April 24, 2007

TO: Members of the MAG Specifications and Details Committee  
FROM: Robert Herz, Maricopa County DOT, Chairman  
SUBJECT: MEETING NOTIFICATION AND TRANSMITTAL OF AGENDA

MEETING MINUTES FROM THE  
MARICOPA ASSOCIATION OF GOVERNMENTS  
STANDARD SPECIFICATIONS AND DETAILS COMMITTEE

April 11, 2007

DETAIL NO. <b>535</b>	STANDARD DETAIL ENGLISH	CATCH BASIN TYPE 'F' (FOR USE WITHOUT CURB)	REVISIONS	DETAIL NO. <b>535</b>
--------------------------	----------------------------	--	-----------	--------------------------

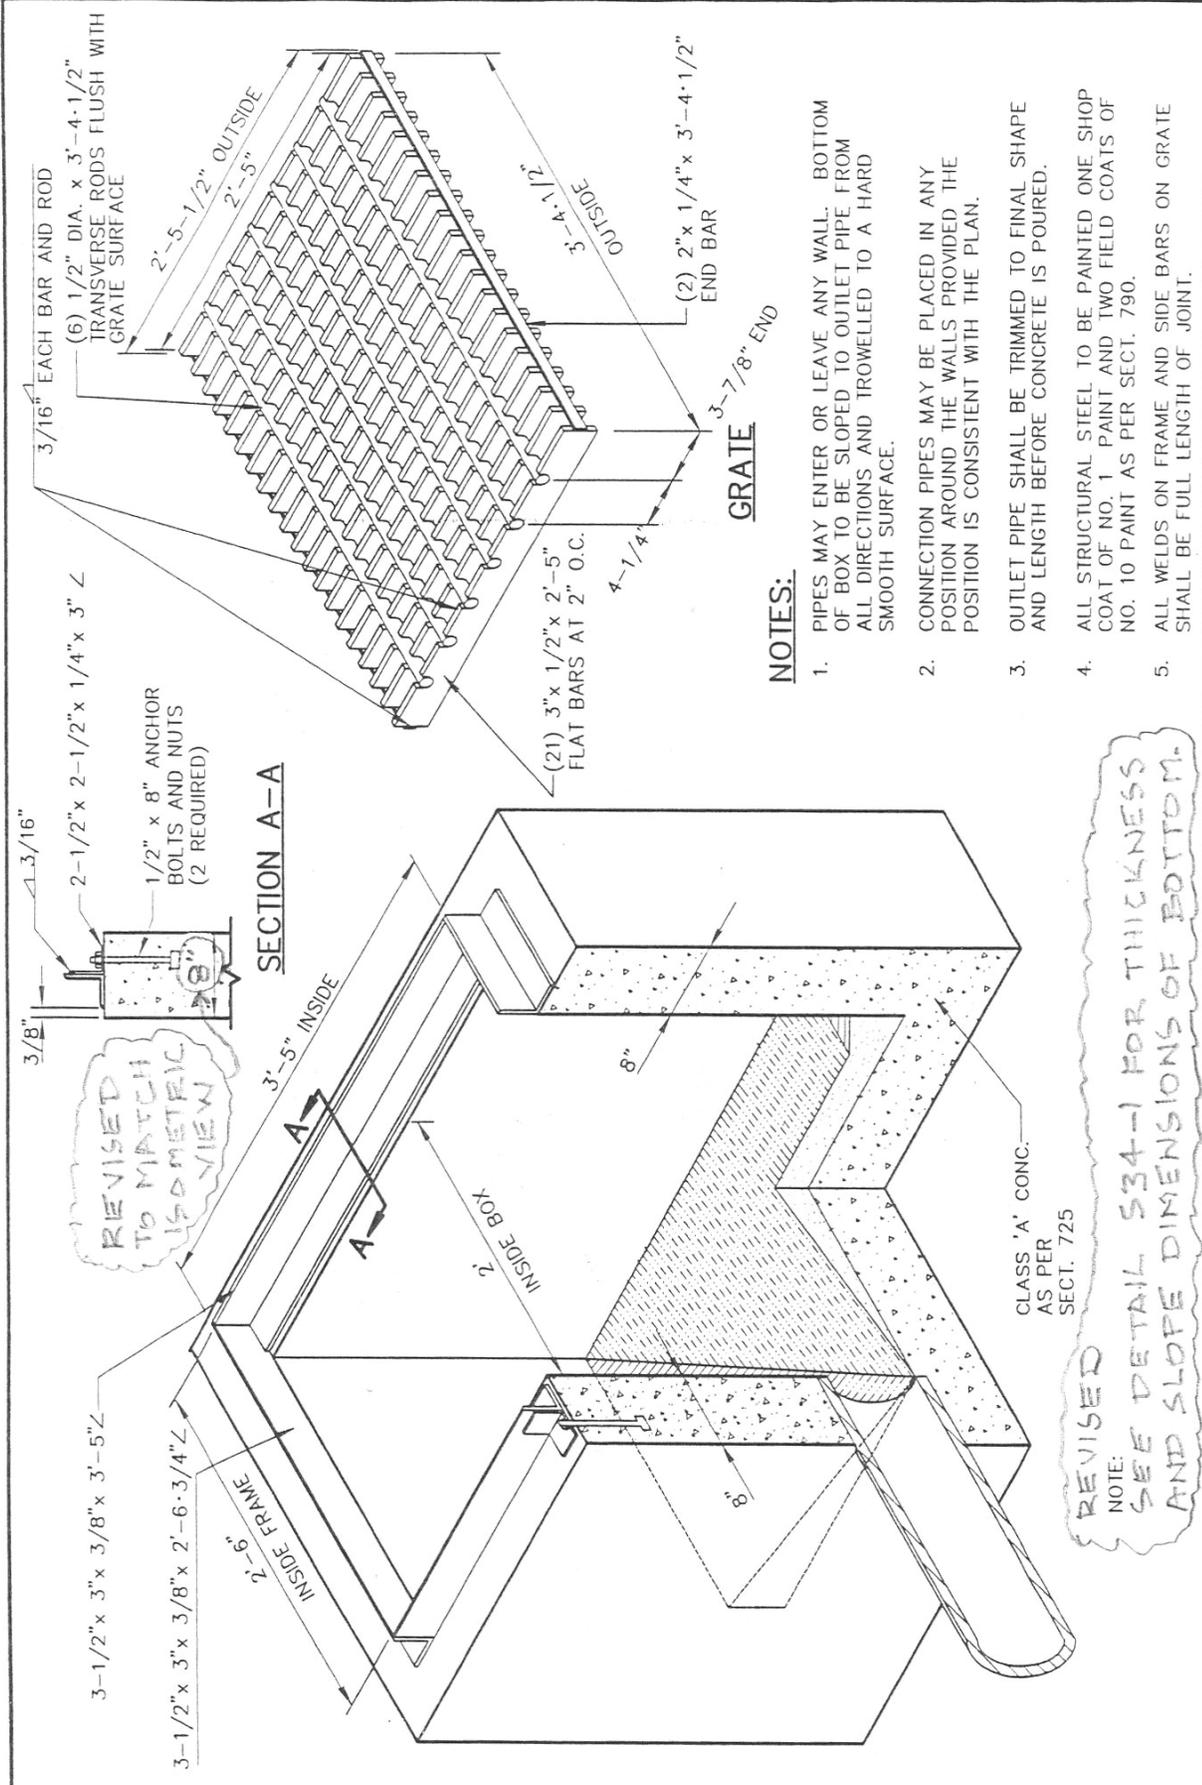
a. **Case 07-01A – Miscellaneous Corrections:** Dimension correction to Detail 535 catch basin type “F”. Revised detail was handed out that included a note referencing basin bottom thickness and slope per Detail 534-1 (see attached). Rod Ramos said that grate outside dimension tolerances were excessive and should be reduced to ¼-inch to improve fit. Dale Phelan noted that it may be easier and less costly to change the frame instead of the grate. Paul Nebeker stated that he would check with a local manufacturer on the difficulty in making any of the changes discussed and get back to the committee on his findings.
